## City of Ketchum

**Recommendation to review the additional materials requested of and submitted by the applicant, hold a public hearing and review any new testimony, and approve with conditions the PEG Ketchum Hotel Design Review**

**PROJECT:** PEG Ketchum Hotel, LLC or Ketchum Tribute Hotel or Ketchum Gateway Hotel

**FILE NUMBER:** P20-019

**1 LEVEL -2 MECHANICAL PLAN - A**  
 1/8" = 1'-0"

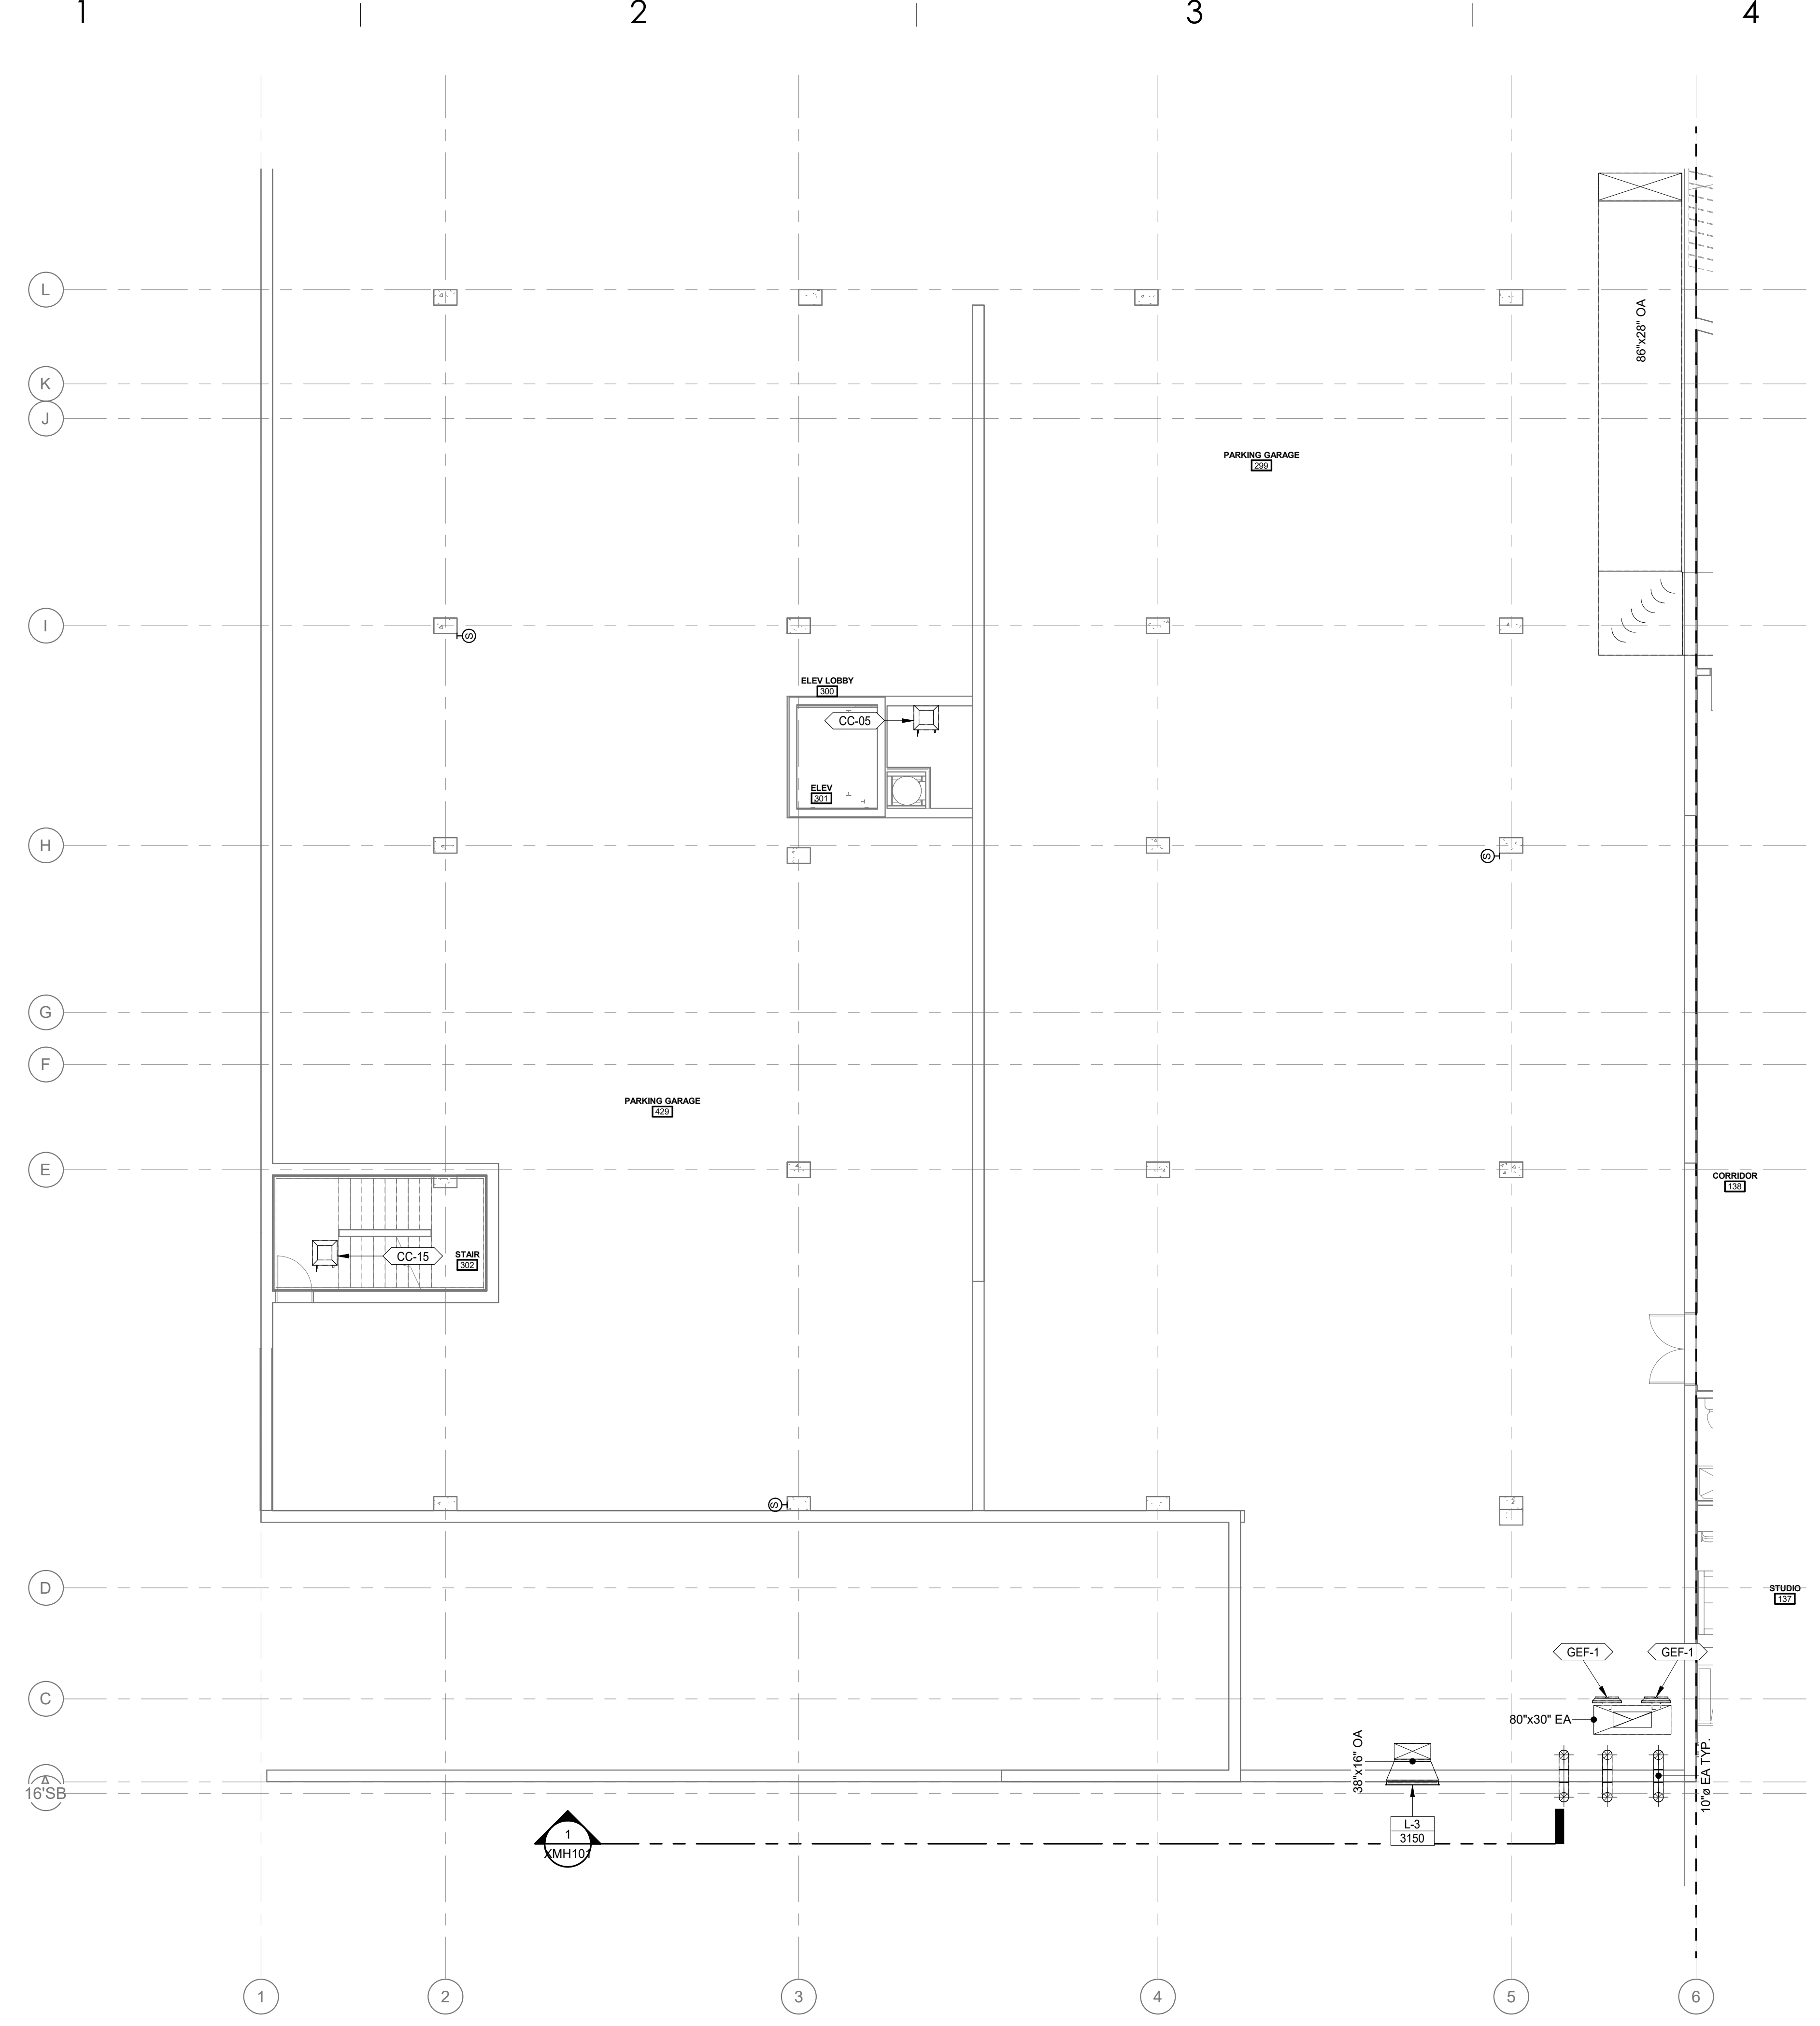
The level -2 portion of the West wall has a louver tagged as L-3. This louver is to provide intake air for the commercial clothes driers. Nearby, there are three 10” dia. ducts penetrating this west wall. These ducts are to provide exhaust for the commercial clothes dryers. They will produce minimal smells and noise. These ducts will produce steam in times of cold weather.

**1 LEVEL -1 MECHANICAL PLAN - A**  
1/8" = 1'-0"

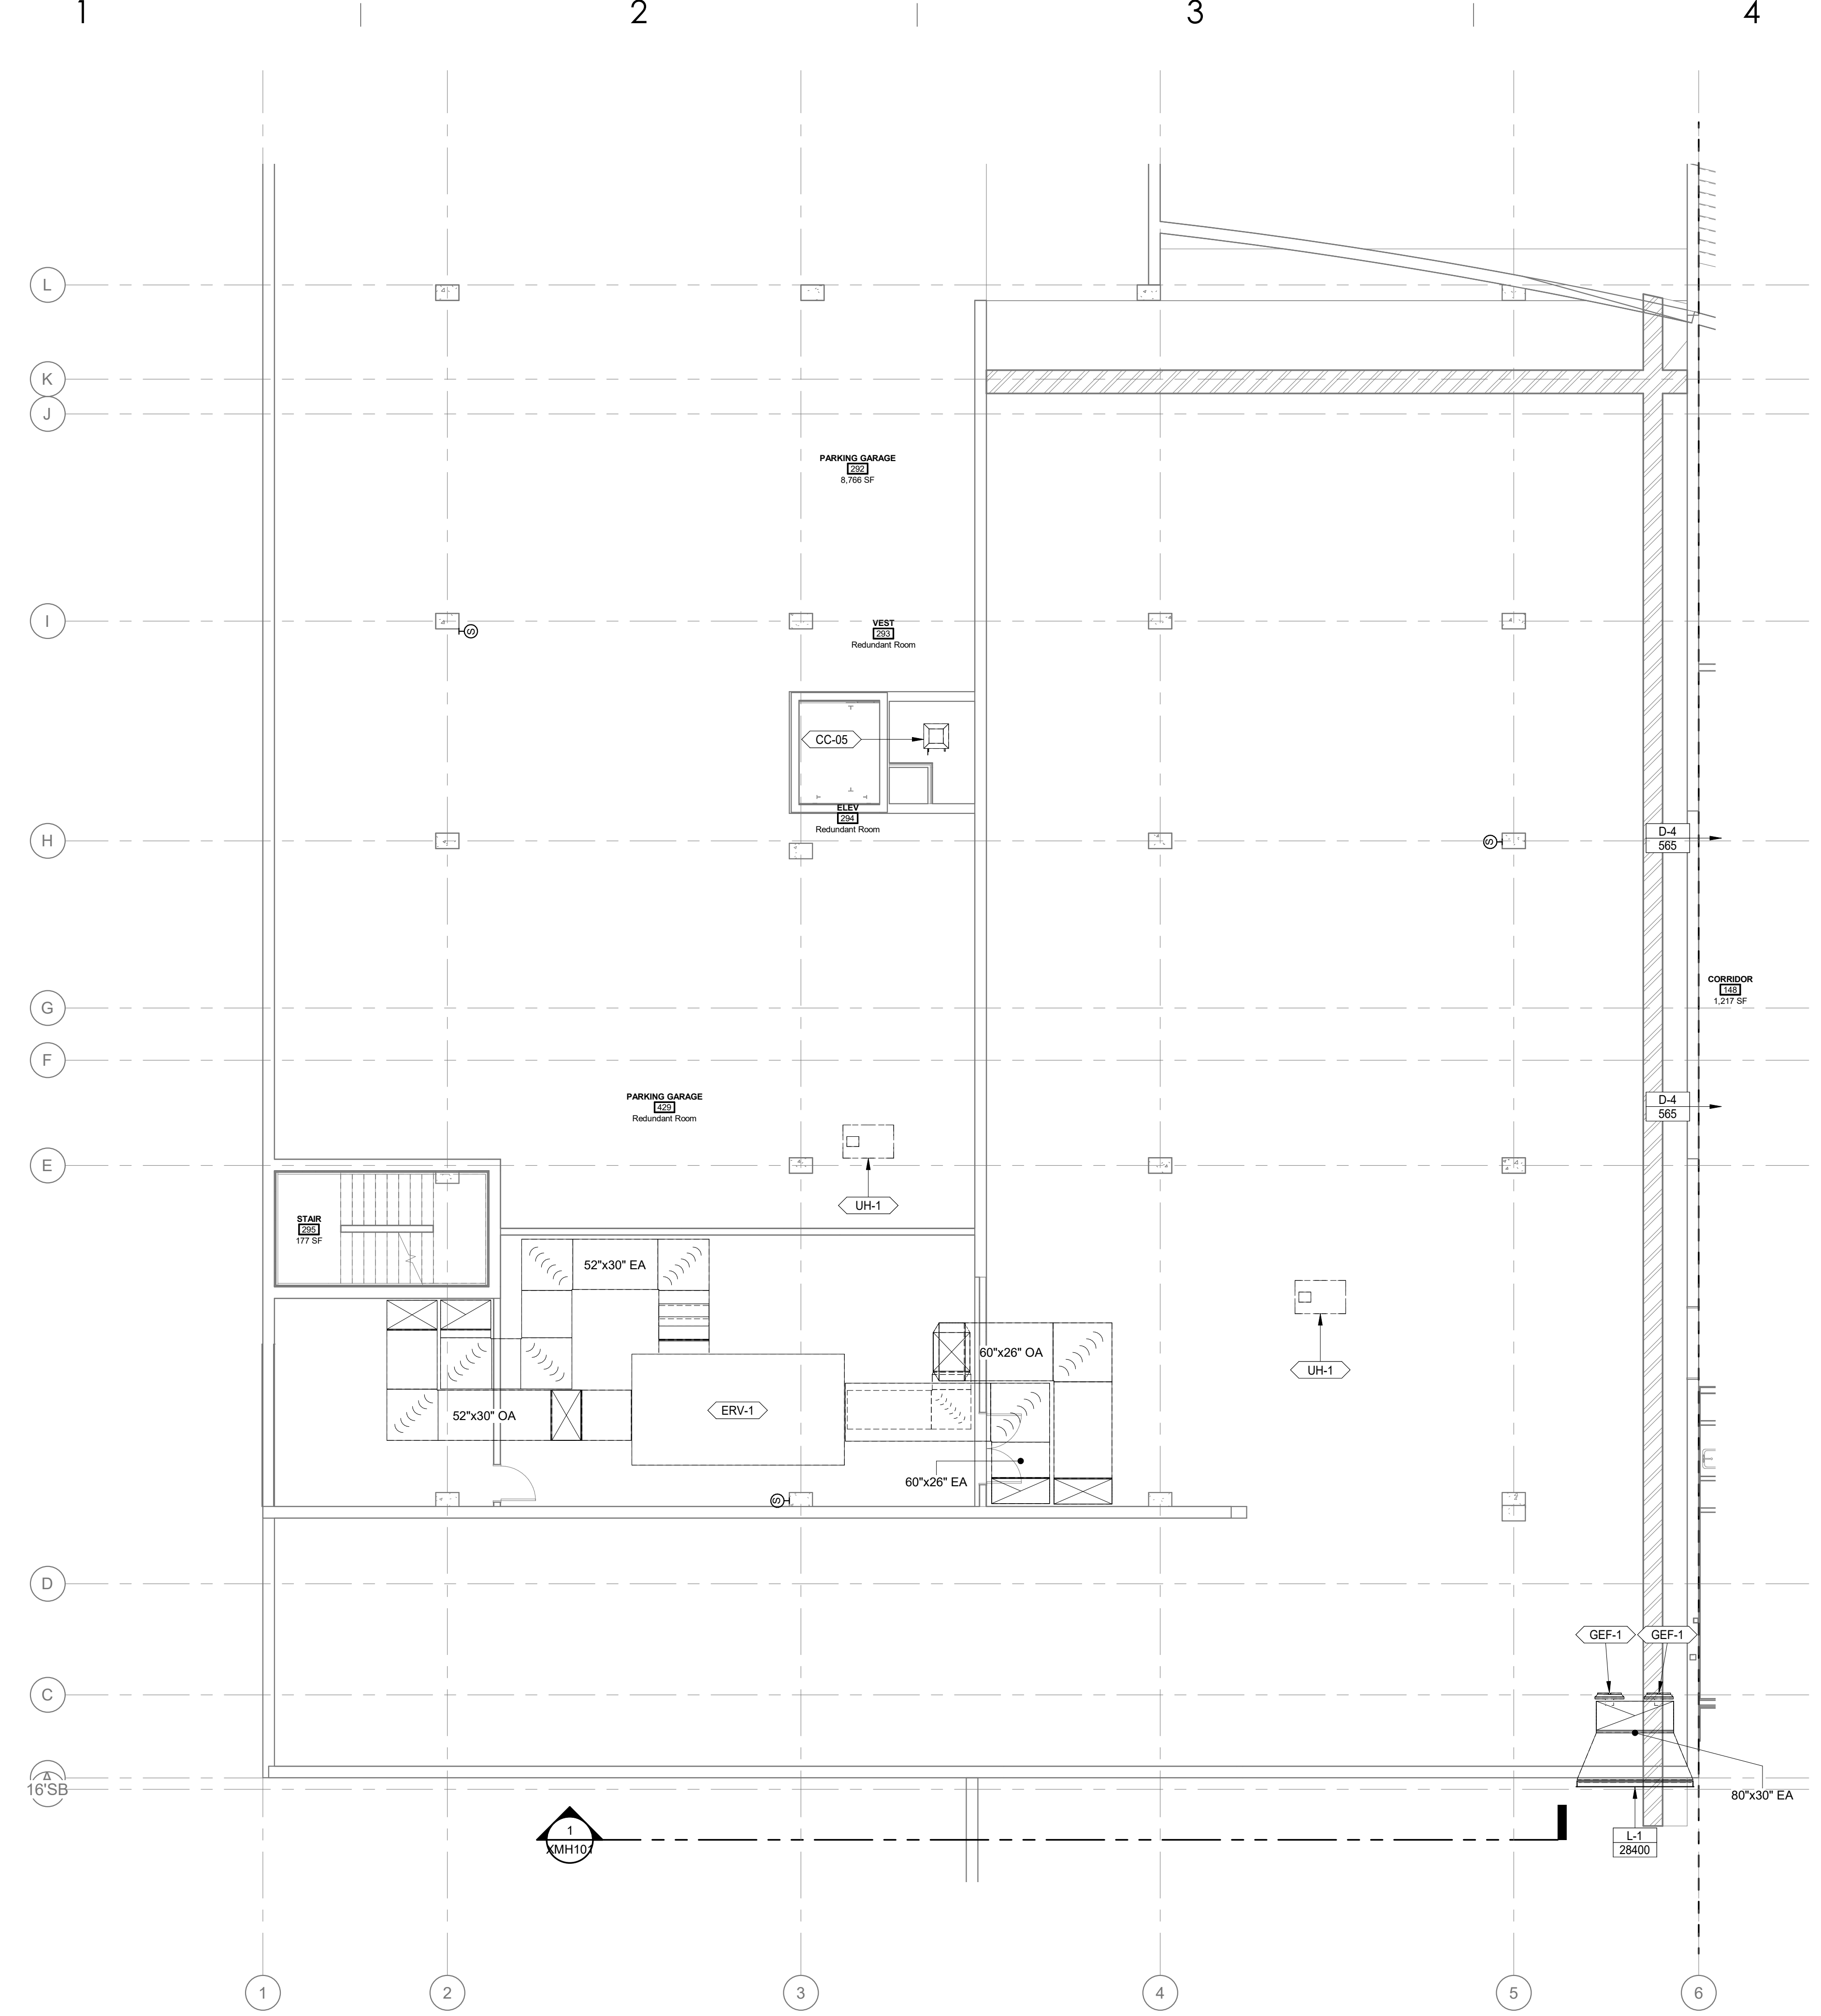
The level -1 portion of the West wall has a large louver tagged as L-1 serving the parking garage exhaust. This louver will not have any noticeable smells, but will create some noise. The noise levels will vary depending on vehicle operation rates in the parking garage. Typically the noise will be very minimal, but the noise will increase upon the call for the garage exhaust. We anticipate the louver to remain under 70 dB.
